Proposal for amendments to GTR No. 6

The text reproduced below was prepared by the expert from the Republic of Korea.

Figure 4: Determination of Zone I ”

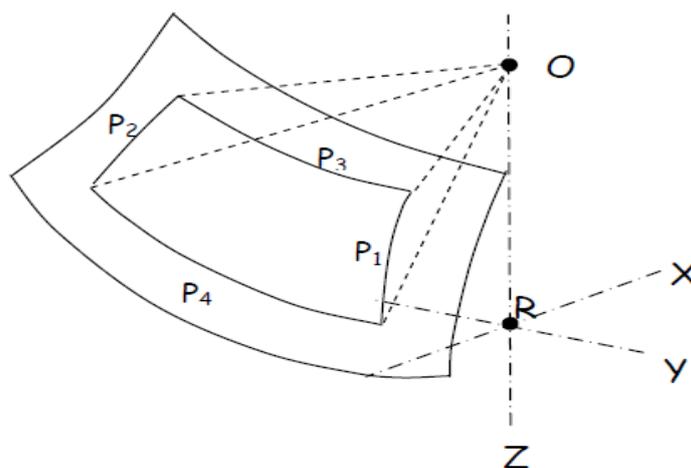
In addition, opaque obscuration can be exempted in Zone I. It is the limited areas where it is intended that a sensing device, e.g. a rain-drop detector, rear view mirror or autonomous sensors, will be bonded to the inner side of the windscreen. The opaque obscuration where such devices may be applied is defined in paragraph 7.1.3.2.4. of this annex.

1. In case that open type loadings tray is applied to trucks, interior mirror application is required to secure rear view.
 2. Additionally, the many kinds of the truck's efficient safety/convenience (LDWS, autonomous vehicle sensors, etc.) options are being under development nowadays.
If these options are fitted to the underside of the wind shield glass, it may limit the driver's direct front of vision. (Possible adverse safety consequences)

3. For the optimization of installation, the options may be integrated with the interior mirror. However it is difficult for some models to install the interior mirror, since area "I" may be intruded.
Therefore, the opaque obscuration which is defined in paragraph 7.1.3.2.4. of Annex is needed to be exempted in Zone I, in order to install those devices.
